SURFACE WATER DRAINAGE – SUPPLEMENTARY REPORT LAND TO THE REAR OF SUNNYSIDE BARN AND FLINT BARN, BARNHAM

For Manorwood Ltd

Report Number: YE4281, Date: May 2020

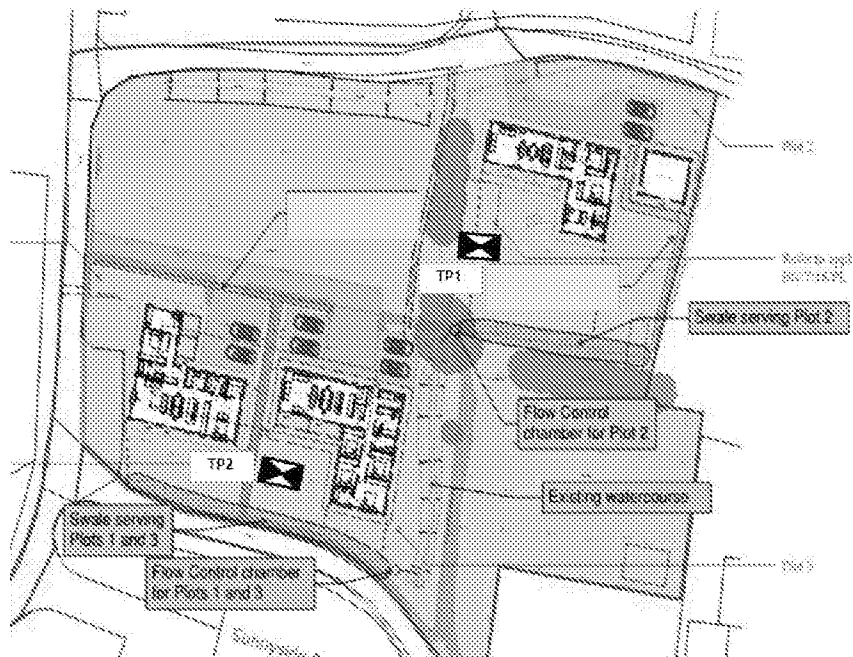
- The groundwater level identified as part of the infiltration testing is unclear. The results state that each pit "filled 60cm within 20mins" from a starting point of 0.9mbgl and 0.7mbgl. On this basis we have read the results as peaking at 0.1mbgl in TP2. (Rather than both pits stabilising at 0.6mbgl). If this is the case the swales will require impermeable liners to avoid groundwater ingress, this will require the design to account for buoyancy. If the groundwater is in fact at 0.6mbgl then the applicant is advised to approach this department to discuss any further required monitoring and/or design options.

It is agreed that the data as presented could have been made more clear. During the excavation of the trial pit water ingress was noted at 0.9m bgl and was reported (verbally) to be perched groundwater which did not prevent the excavation from continuing to the target depth of 2.0m bgl. Once the excavation was complete water filled the excavation by 60cm (to 1.4mbgl) within 20mins. It is our contention that the design groundwater level is at 1.4m bgl (at TP1 and at TP2).

The Trial Pits were excavated in the positions shown below (not provided in the previous report). The ground levels at these locations are approx. 9.3m AOD for TP1 and approx. 9.1m AOD for TP2. Therefore, it may be stated that the groundwater level in TP1 has been measured at approx. 7.9m AOD at TP1 and at 7.7m AOD at TP2.

This would make sense as the watercourse which passes through the site has a bed level at between 8.2m AOD and 7.95m AOD. The lowest level being at the culvert which drains the site southwards. It would make sense that this watercourse prevents the groundwater from rising to the ground levels found across the site.

PROJECT FLINT BARN BARNHAM	TITLE FLINT BARN DRAINAGE DESIGN
DESCRIPTION DRAINAGE DESIGN	
CLIENT ADDRESS Flint Barn Yapton Road Barnham Bognor Regis PO22 0AZ	DRAWING CLASSIFICATION PRELIMINARY ISSUE
DRAWING NUMBER FLB0101	REV. P03

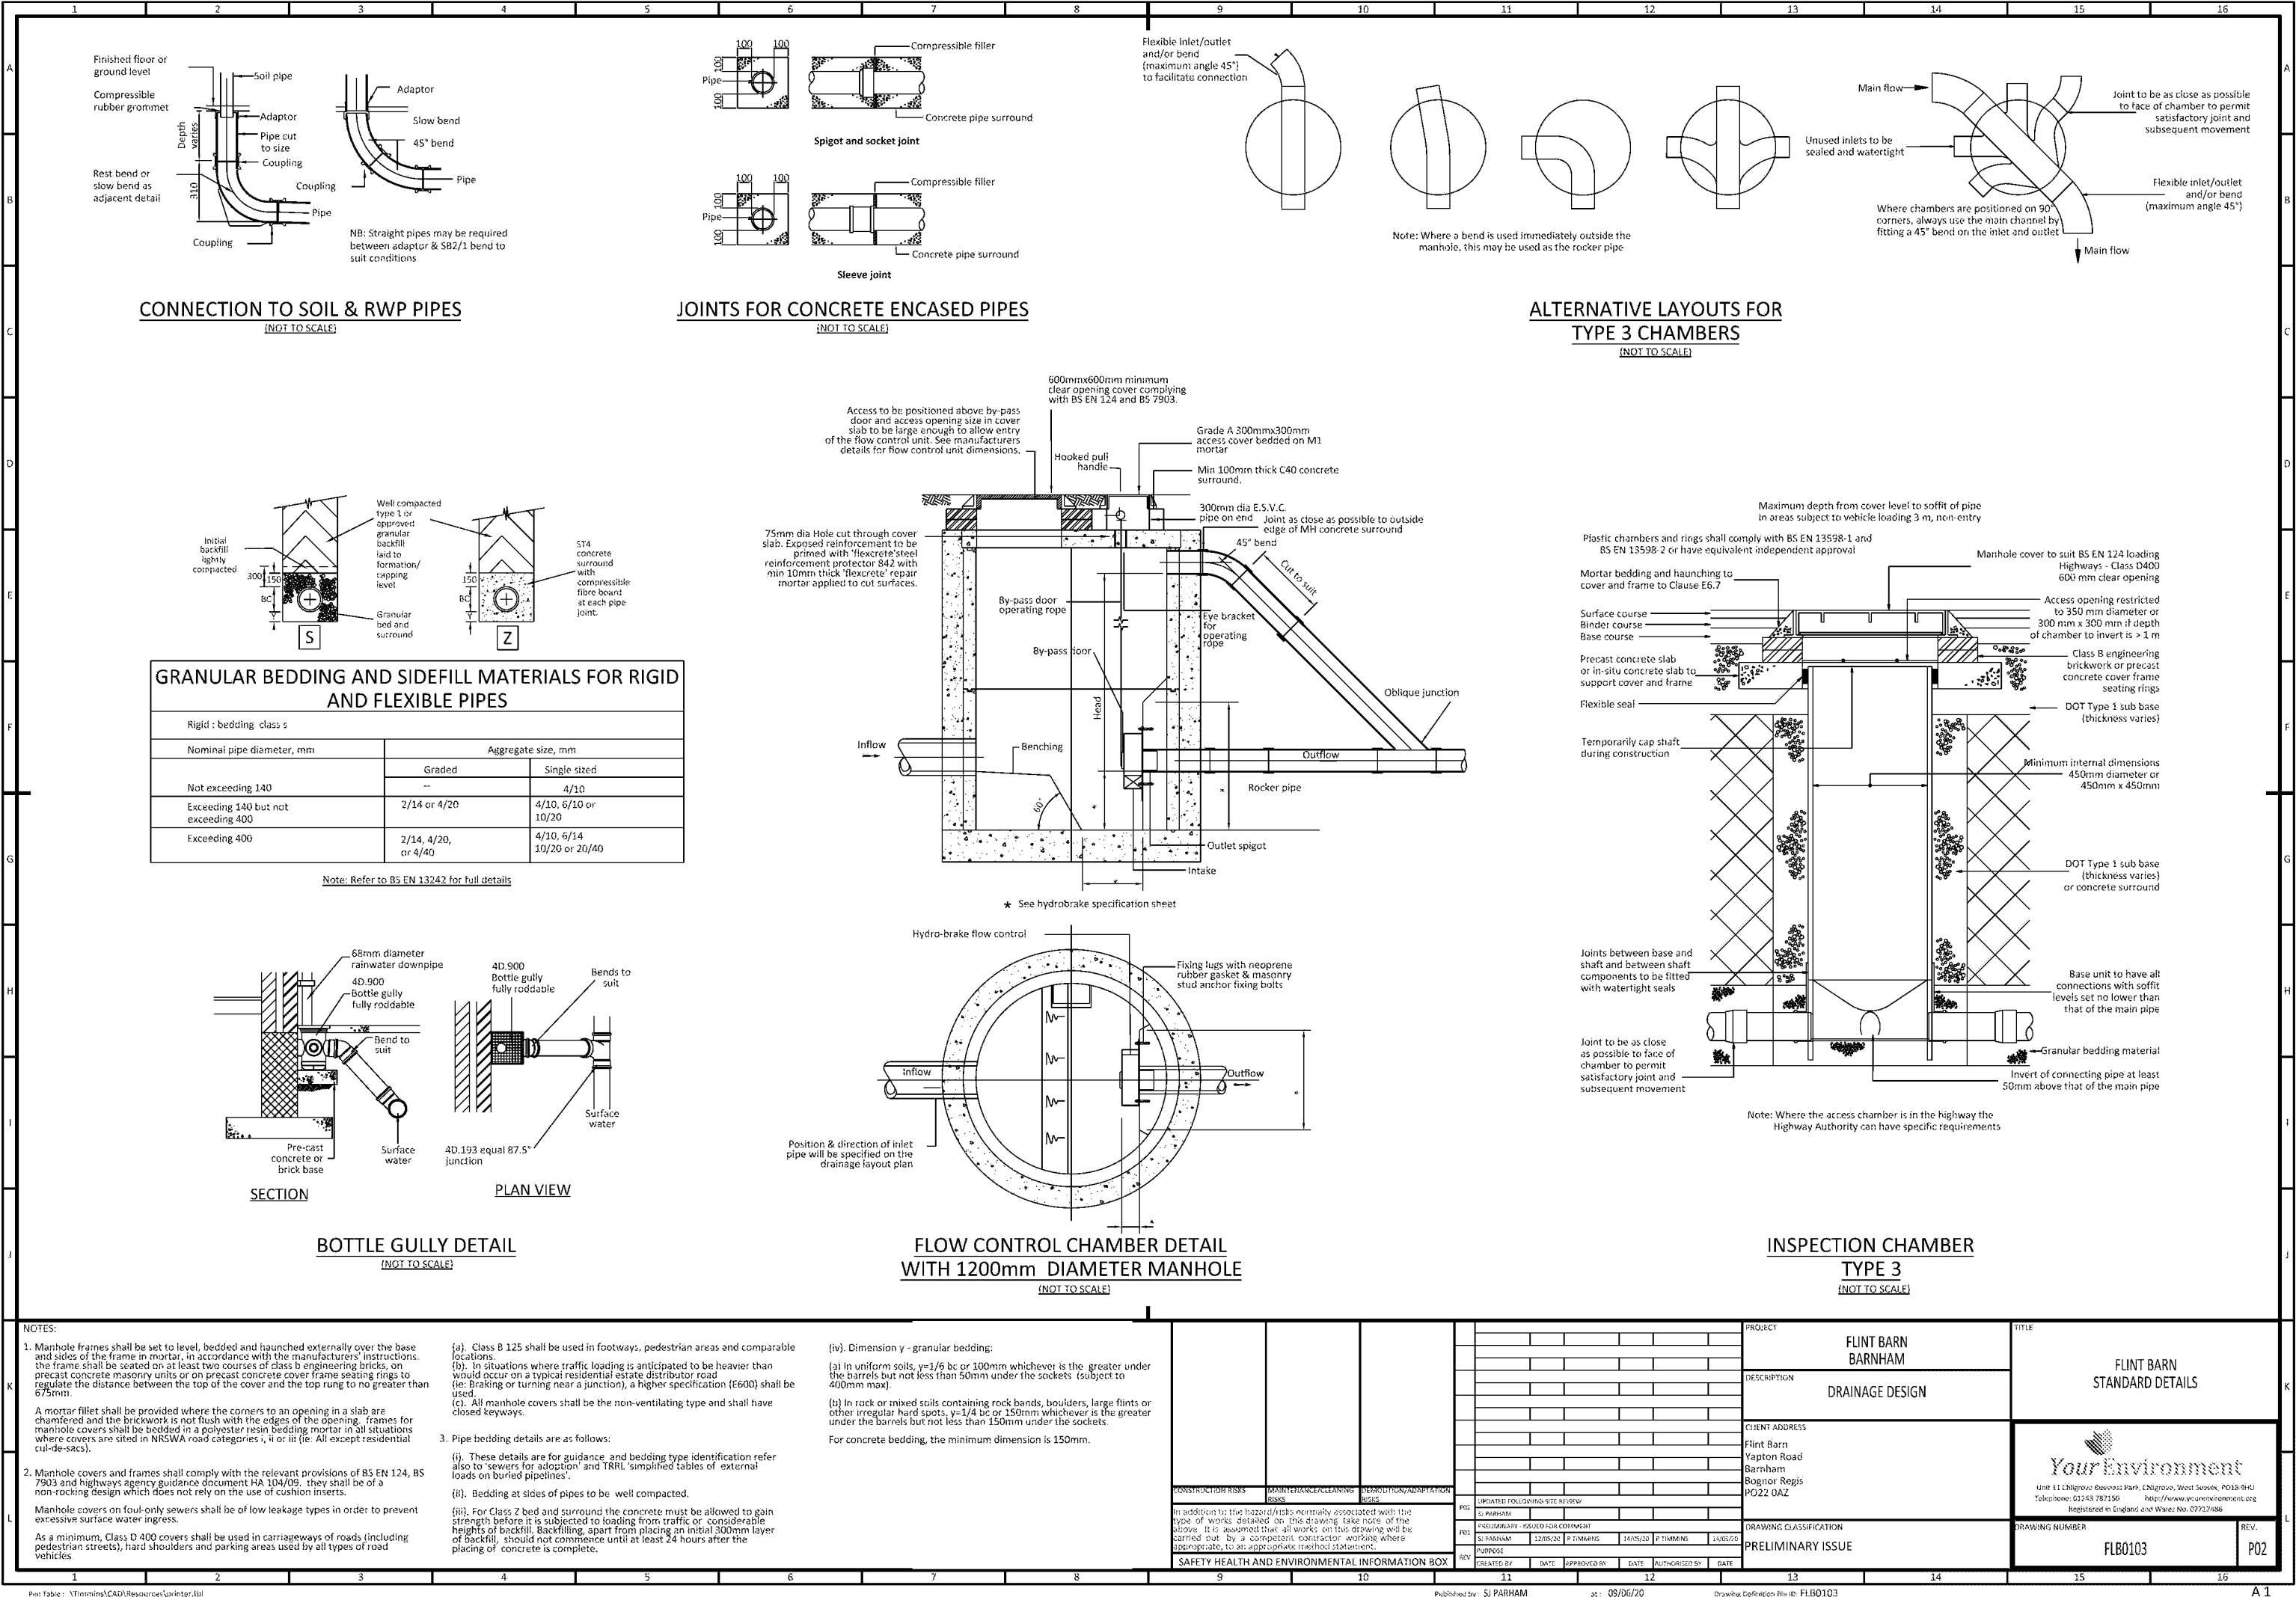
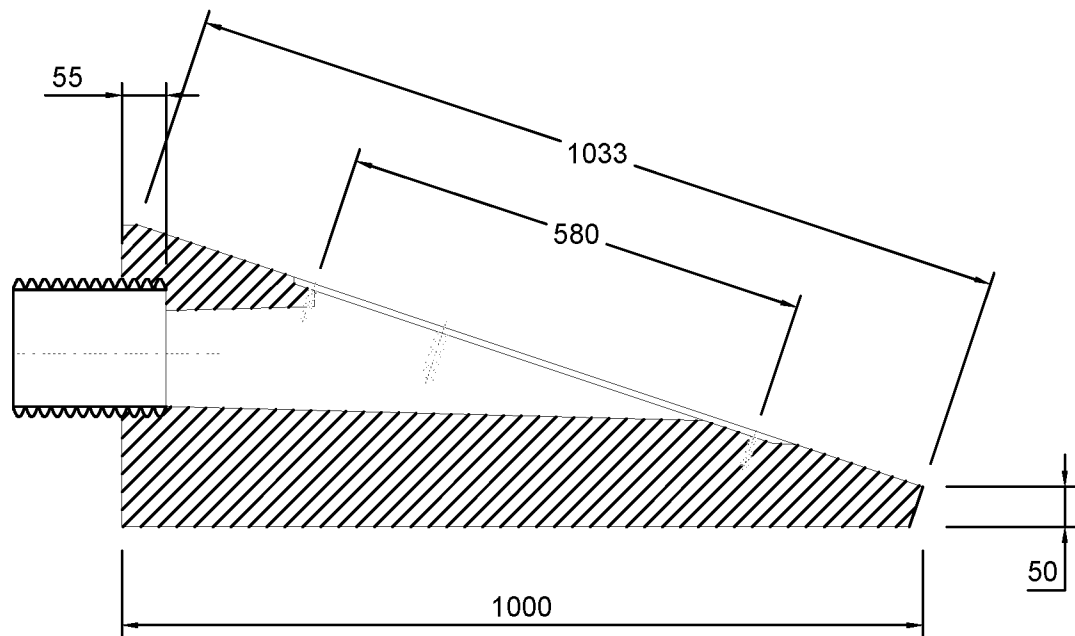
4. A pipe is believed to enter the watercourse at the north end of it, all structures must be kept further than 3m from this.

5. All buildings and fences must be minimum 3m from the top of the ditch bank.

The 3m offset from the north-end of the watercourse has been indicated on the latest layout plan. An extract of that plan is provided below and in full within Appendix B. The pipe that enters the north end of the watercourse is redundant and not connected to anything, it is approximately 6ft long and laid in the ground.

Nevertheless, all structures and fences are a minimum of 3m from the top of the ditch and swales

The plan layout of the development has been adjusted in order to achieve this constraint. As above all structures and fences are a minimum of 3m from the top of the ditch and swales

A Drainage Layout for the development is provided in Appendix B. An extract of that drawing is provided below:
